In response to your application dated August 30, 1979, supplemented by letters dated October 24, 1979 and March 7, 1980, the Commission has issued the enclosed Amendment No. 51 to Facility Operating License No. DPR-30 for Quad Cities Station Unit 2.

QUAD CITIES UNIT NO. 2

Amendment No. 51
License No. DPR-30

ATTACHMENT TO LICENSE AMENDMENT NO. 51
FACILITY OPERATING LICENSE NO. DPR-30
DOCKET NO. 50-265

FIGURE 3.5-1

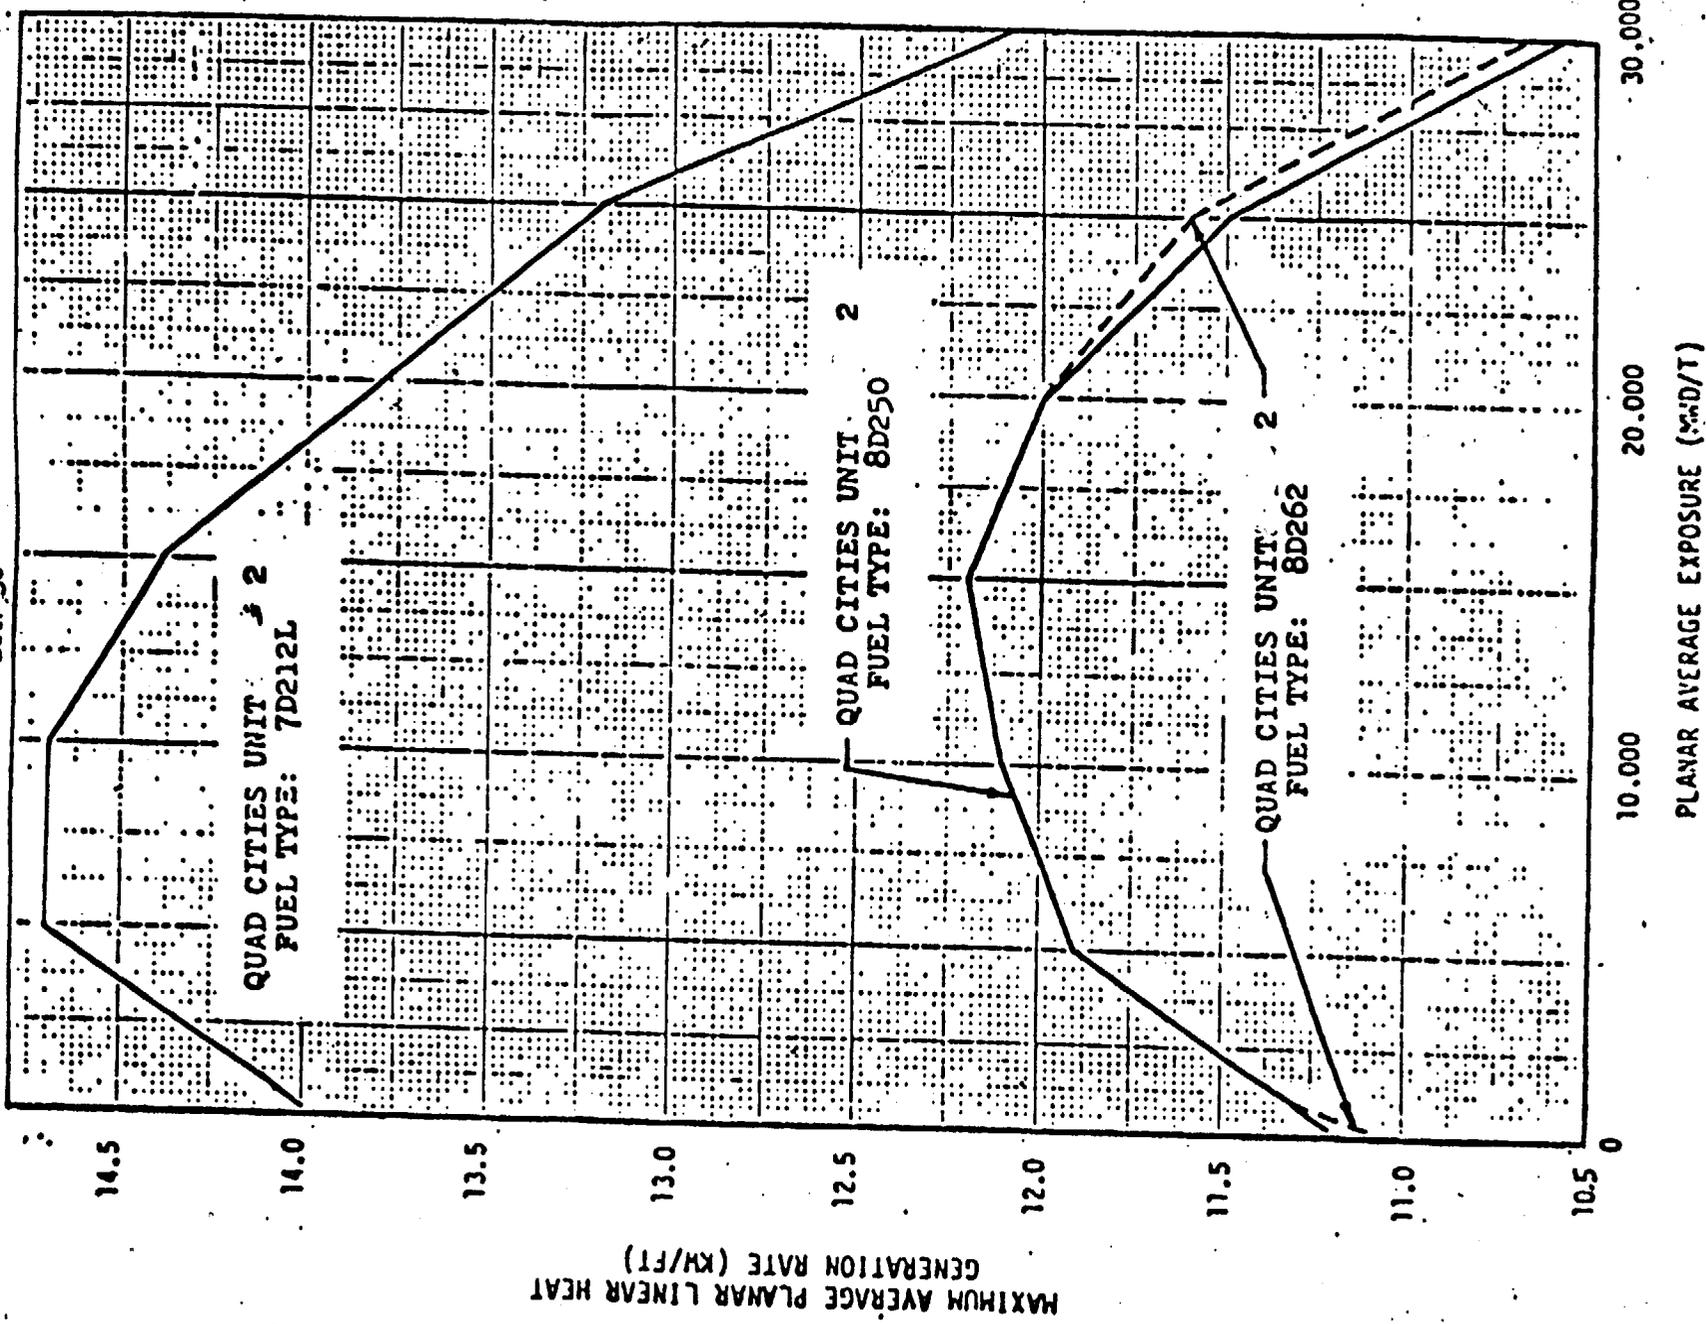
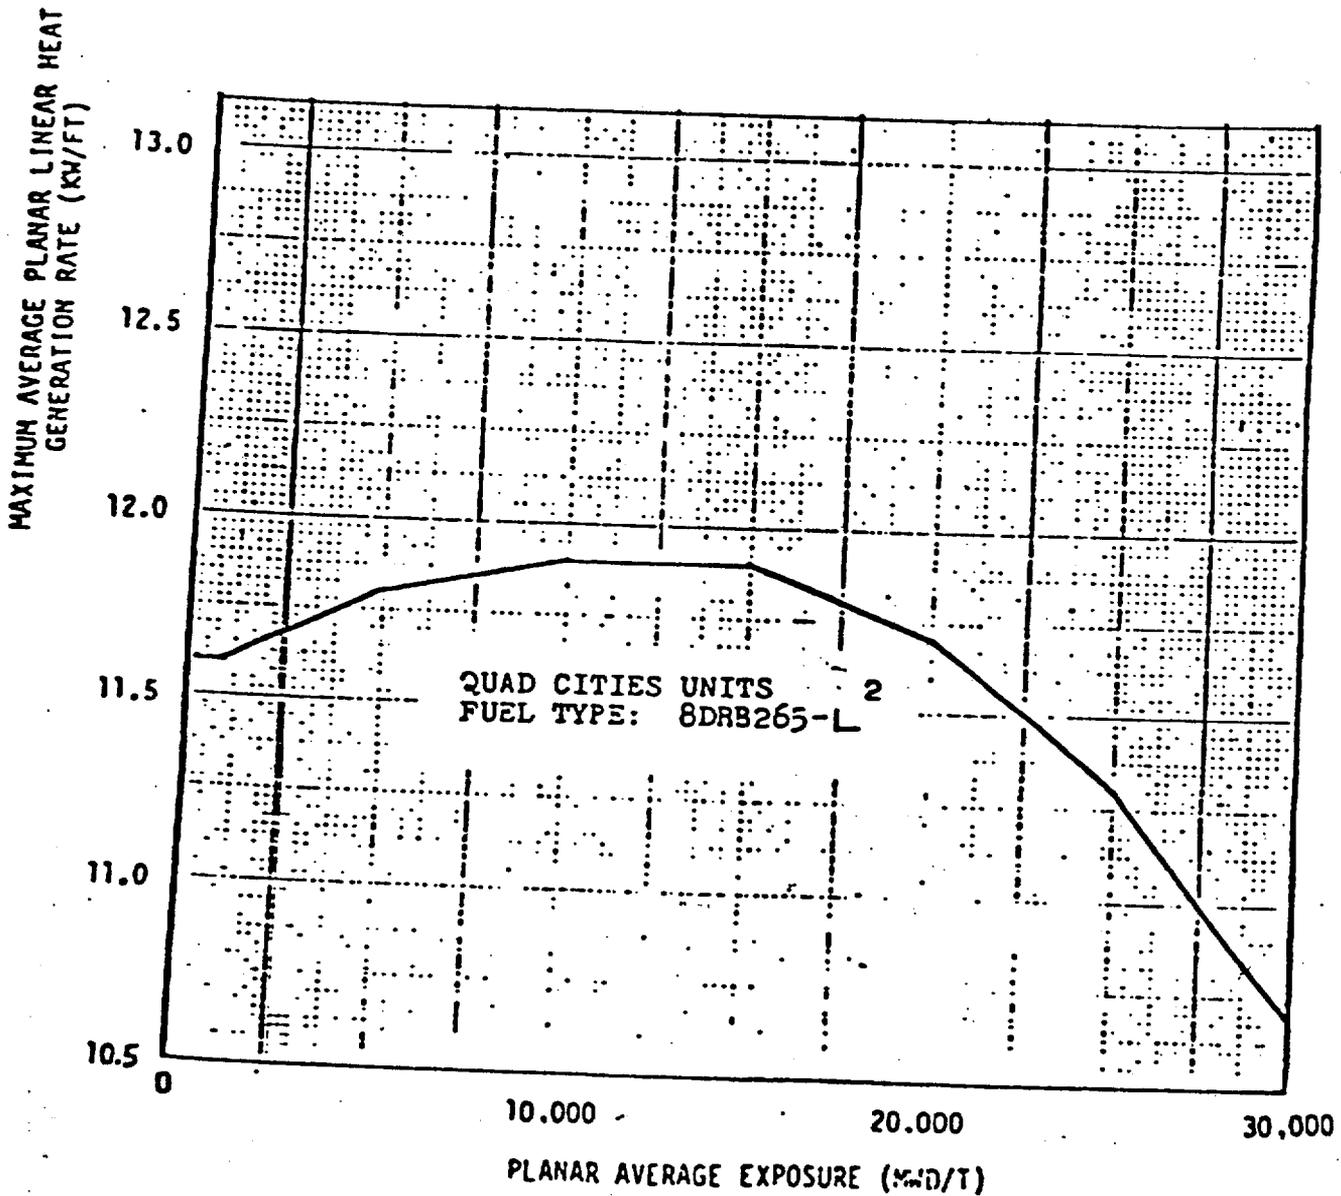
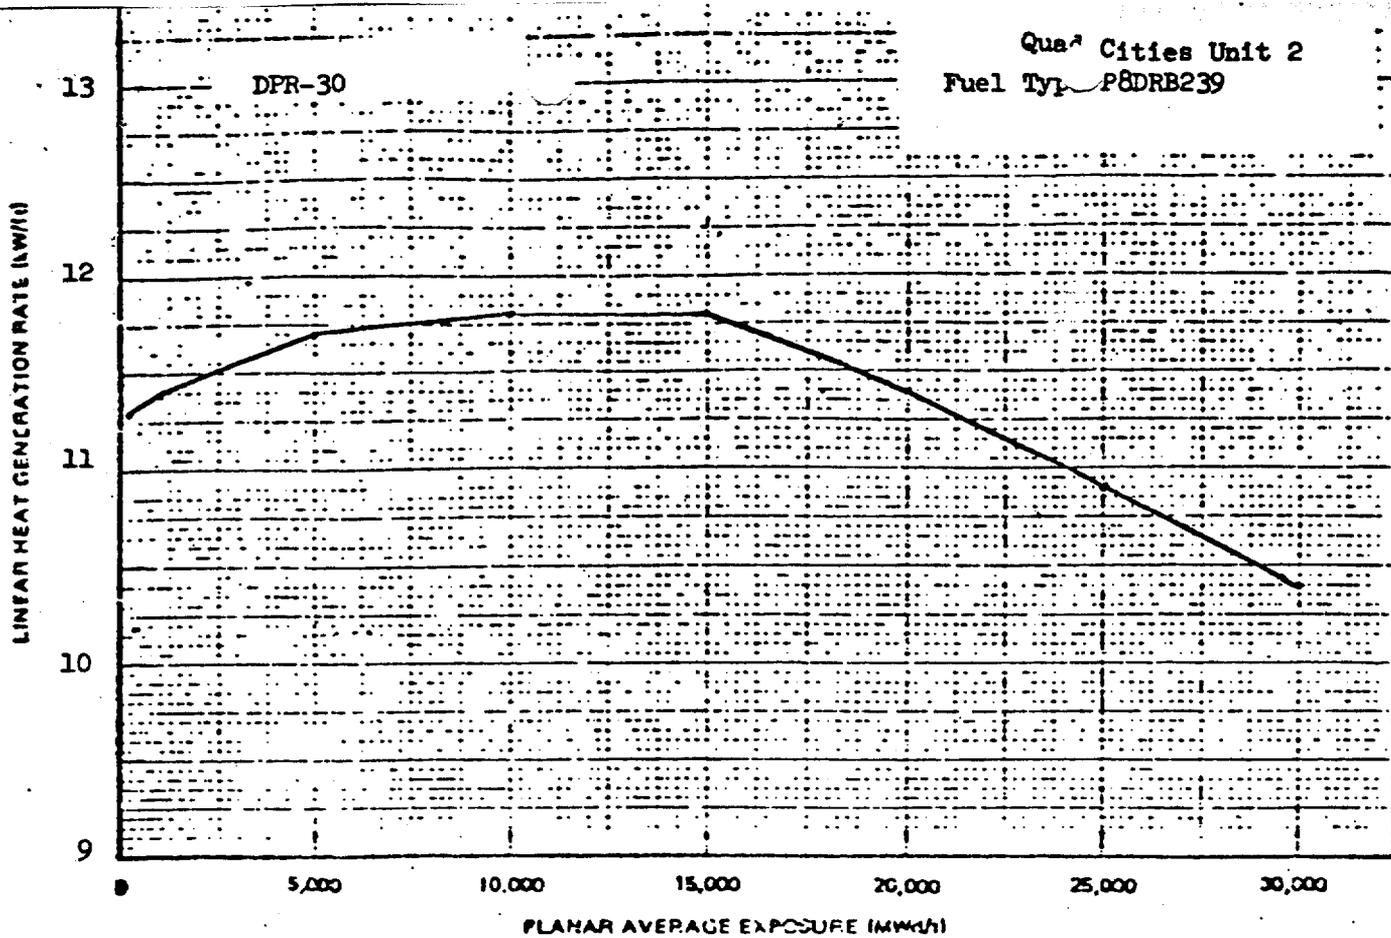
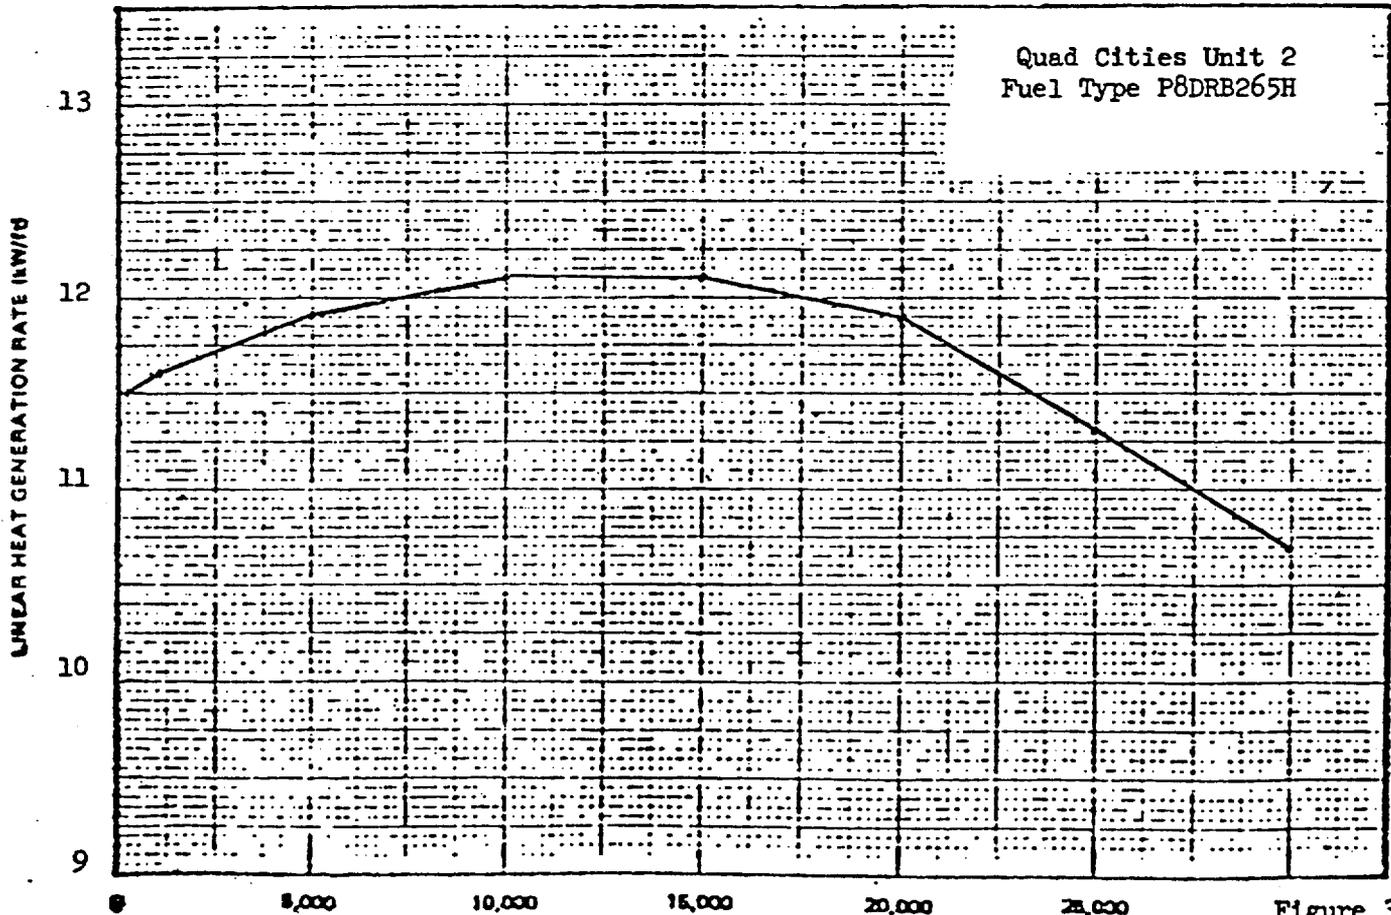
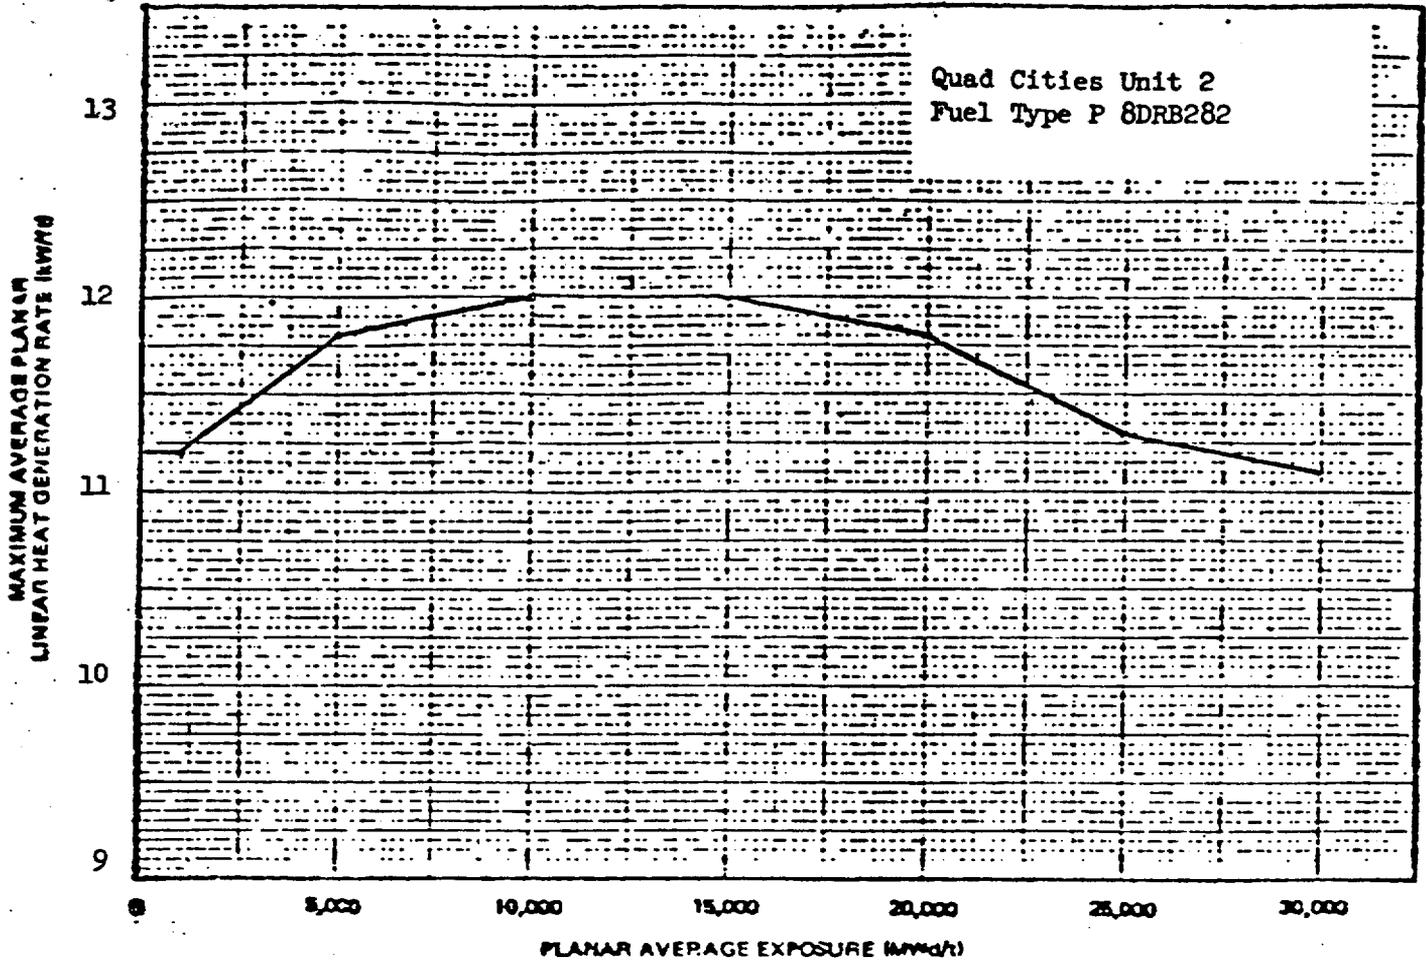
3. Figure 3.5-1 is being replaced by 4 pages.

New MAPLHGR curves from Reference 6 have been proposed. This employed methodology accepted for QC-2 in Reference 7. The only change to Reference 6 from that previously accepted is to incorporate prepressurized fuel in the analyses. This addition was performed in compliance with our guidelines in our acceptance of prepressurized fuel application (Reference 8). Therefore, the use of Reference 6 continues to be acceptable for QC-2 and the addition of Reference 6 MAPLHGR curves to the Technical Specification is also acceptable.
